AMENDMENT

ETS 300 347-1

A1

**Signalling Protocols and Switching (SPS);
V interfaces at the digital Local Exchange (LE);
V5.2 interface for support of Access Network (AN);
Part 1: V5.2 interface specification**

Page 249, figure L.36.7

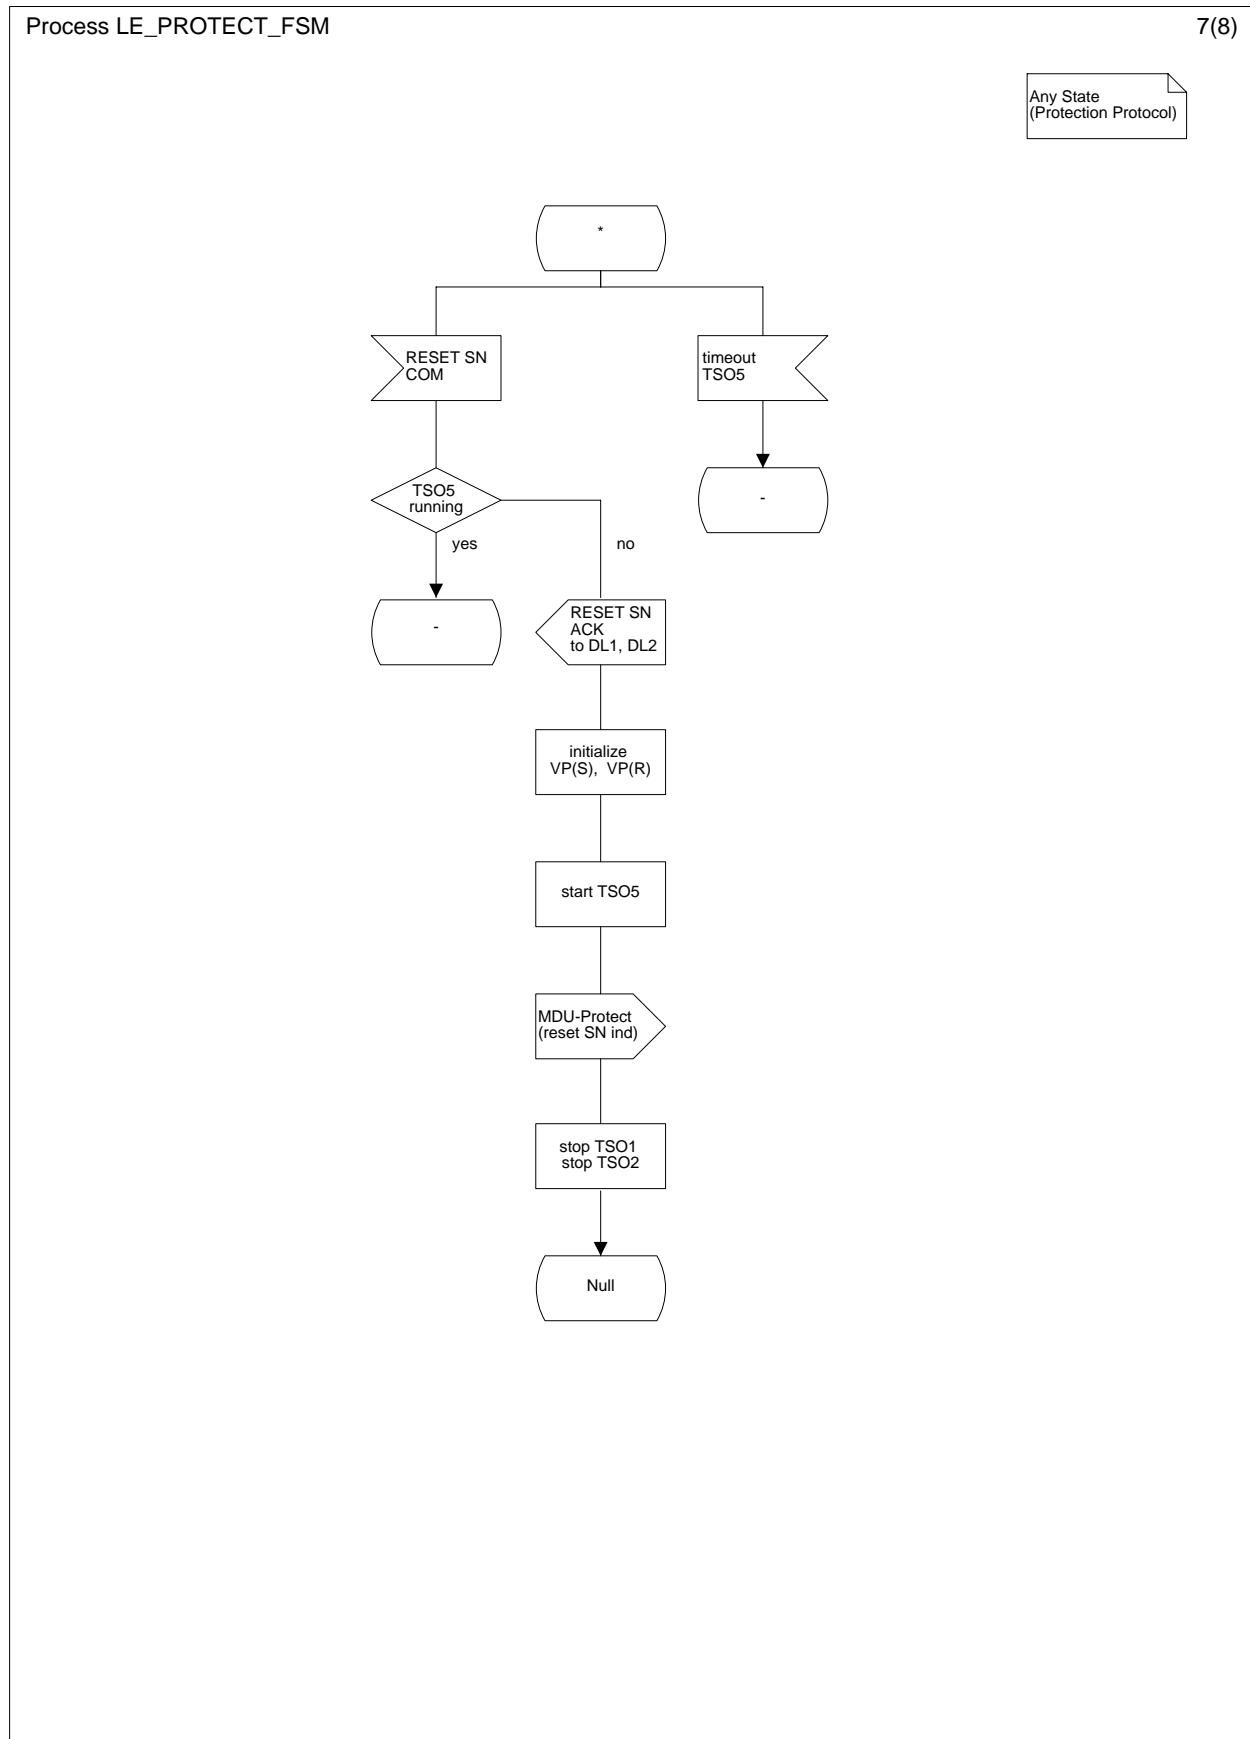
- Annex L, figure L.36.5: A stop of timer TSO2 is missing in the bottom left branch.
- Annex L, figure L.36.7: In the bottom diagram, the symbol for the message RESET SN ACK has the wrong direction.

Flip the output symbol "RESET SN ACK".
